Serial No. 13-139  
LIC/NW/R0  
Docket No.: 50-305  
License No.: DPR-43

**DOMINION ENERGY KEWAUNEE, INC.**  
**KEWAUNEE POWER STATION**  
**TECHNICAL SPECIFICATIONS BASES CHANGES AND TECHNICAL**  
**REQUIREMENTS MANUAL CHANGES**

**KEWAUNEE POWER STATION TECHNICAL SPECIFICATIONS BASES CHANGES**

Figure 8.8.3-1  
EDG Ventilation Damper Control Air Supply Pressure and System Leakage Limitation Curve

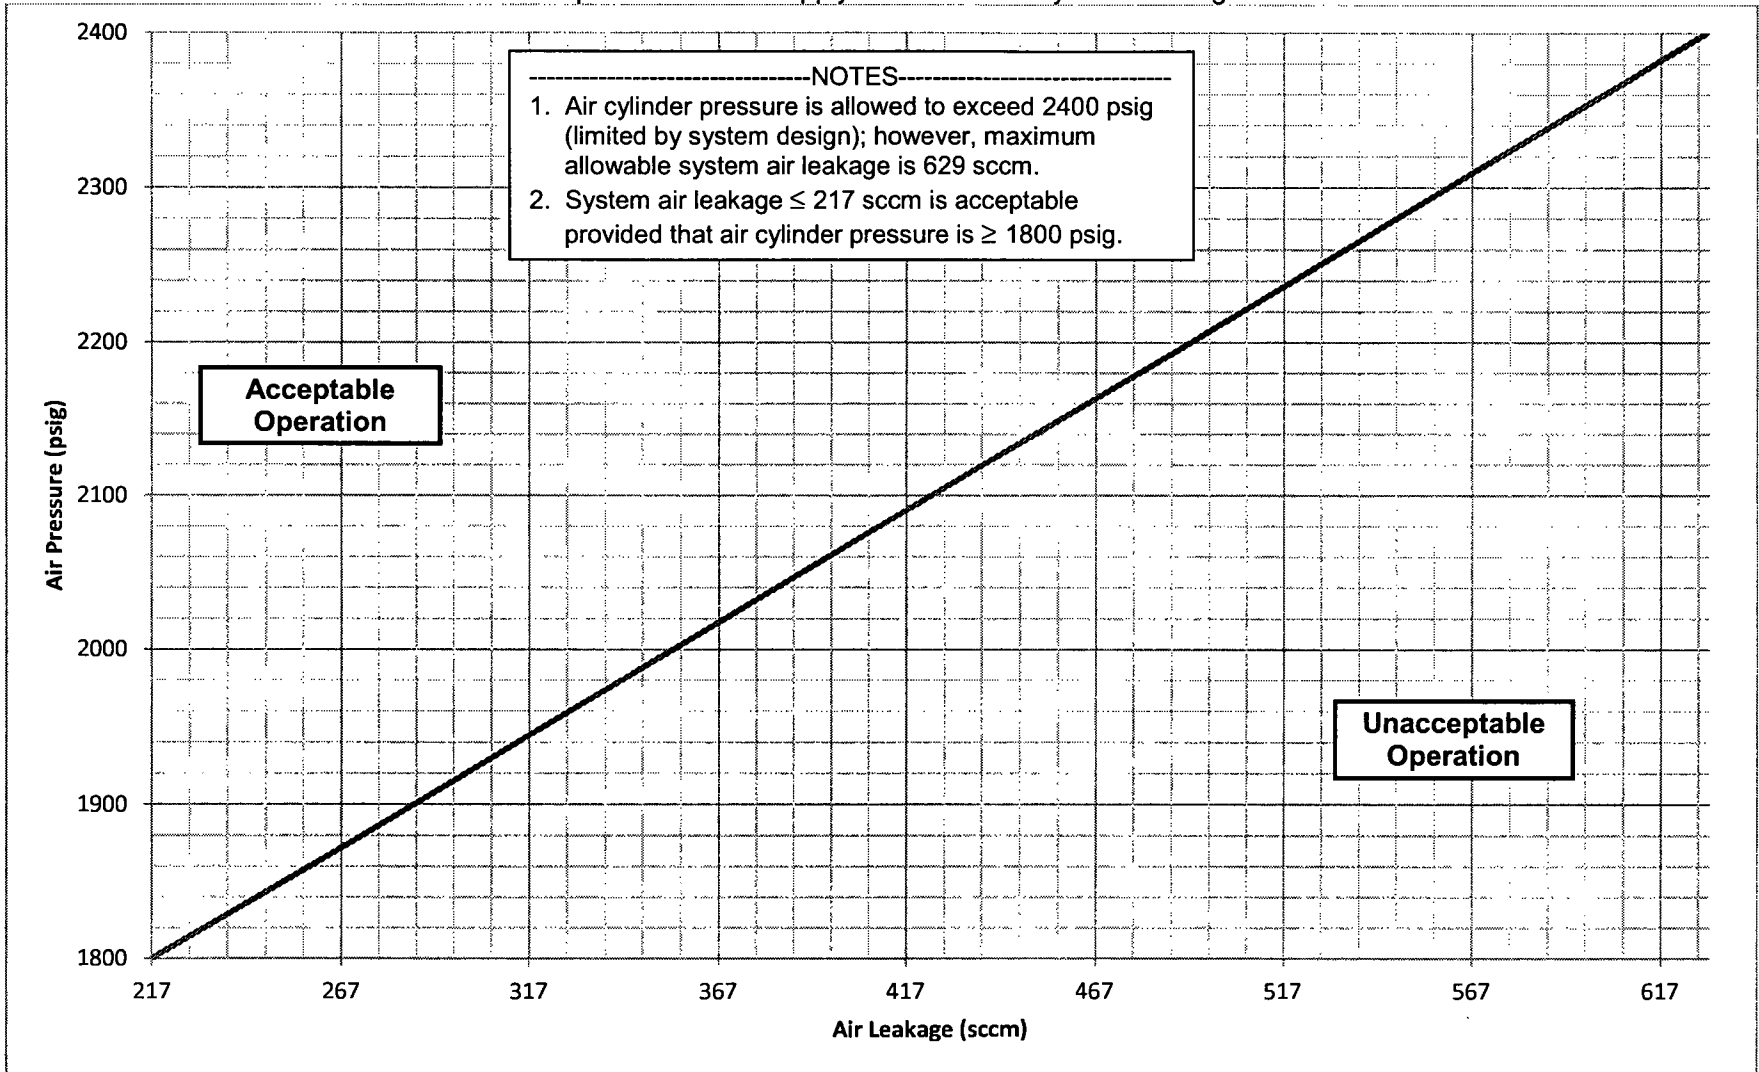
Air leakage and corresponding pressure limits are specified in Figure 8.8.3-1 (and in procedures). Maximum allowable air system leakage varies depending on actual air cylinder pressure. The pressure and leakage limits specified in Figure 8.8.3-1 are based on maintaining a seven-day air supply. This correlates to an allowed leak rate of 217 sccm with air cylinder pressure at the minimum allowed value of 1800 psig, and 629 sccm with air cylinder pressure at 2400 psig.

Cylinder air pressure and system air leakage must be maintained in the Acceptable Operation portion of the limitation curve of Figure 8.8.3-1. This figure is modified by two Notes. Note 1 permits operation with cylinder air pressure above 2400 psig, provided air leakage is  $\leq 629$  sccm. Air pressure above 2400 psig results in a larger supply of air and is acceptable. The maximum allowable pressure is limited by system design and is administratively controlled. However, air leakage above 629 sccm indicates unacceptable system degradation and is not allowed. Such excessive leakage must be addressed in accordance with Nonconformance B. Note 2 permits operation with air leakage  $\leq 217$  sccm, provided cylinder air pressure is  $\geq 1800$  psig.

The minimum required cylinder air pressure corresponding to the existent system air leakage (per Figure 8.8.3-1) must be administratively maintained (e.g., if system air leakage is 355 sccm, then a required minimum cylinder air pressure of 2000 psig must be administratively maintained).
